802.I QCC SPONSOR BALLOT COMMENT #i-22 “DECLARING MORE MSRP STREAMS”

January 2018

GOAL: INCREASE NUMBER OF STREAMS IN MSRP

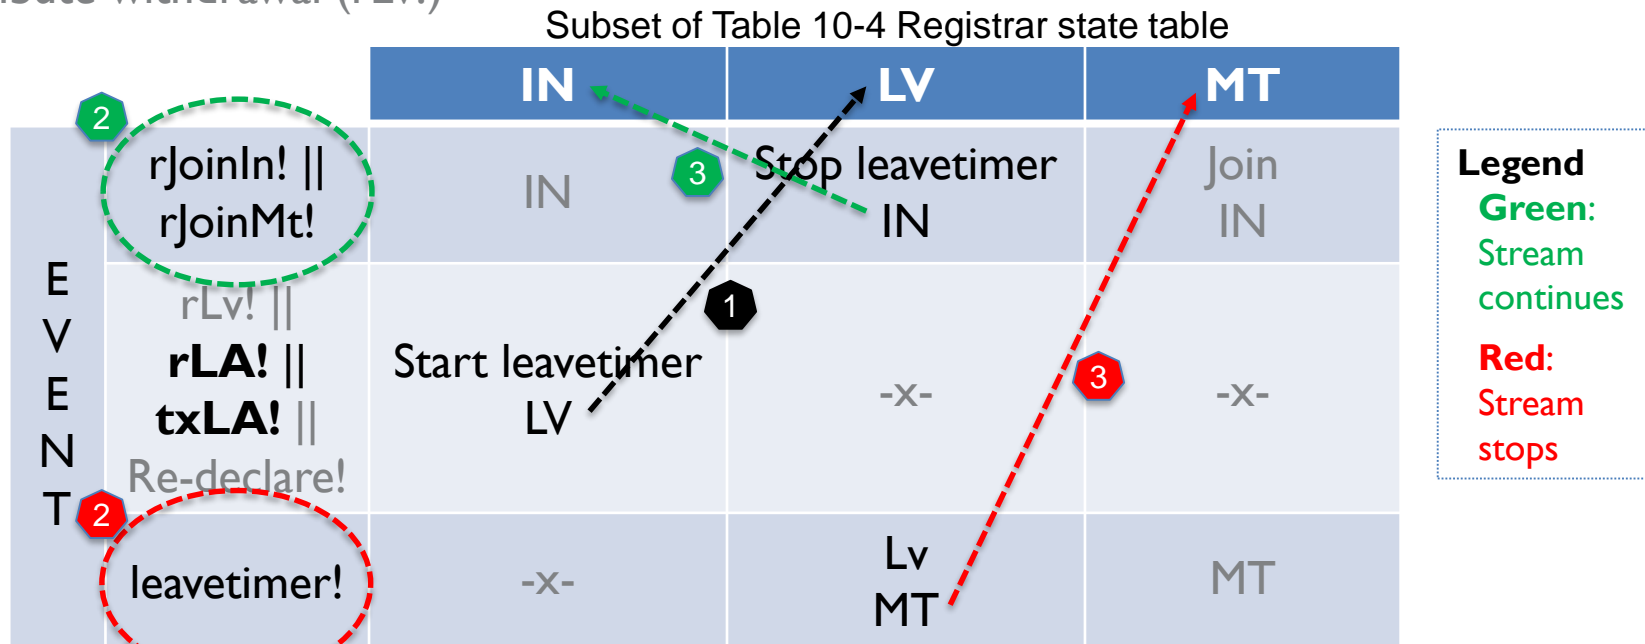
According to the *MRP Timers – Maximum attribute registrations* presentation I gave in 2010 ([at-cgunther-mrp-timers-0310-v02.pdf](#)) you can expect a worst-case maximum of 530 streams. In that presentation I listed MRP configuration options that can be used to increase that number:

- **Lengthen LeaveTime** (default = 600-1000 msec)
Purpose: Controls how long to wait for an attribute to be defended, as a result of receiving a LeaveAllEvent or a Leave, before the attribute is withdrawn.
Benefit: Waiting longer allows more attributes to be declared.
Detriment: <the reason for my Sponsor Ballot comment #i-22>
My current recommendation: **Required to achieve goal!**

- **Lengthen LeaveAllEvent timer** (default = 10 seconds)
Purpose: Controls how often “trash collection” occurs.
Benefit: Waiting longer allows more attributes to be declared between events.
Detriment: Stale attributes take longer to be removed.
My current recommendation: Use if necessary.

- **Shorten JoinTime** (default = 200 msec)
Purpose: Controls frequency of MSRPDU transmissions.
Benefit: Allows attributes to be declared in less time.
Detriment: Increases contention for SR Class interval bandwidth.
My current recommendation: Don't use.
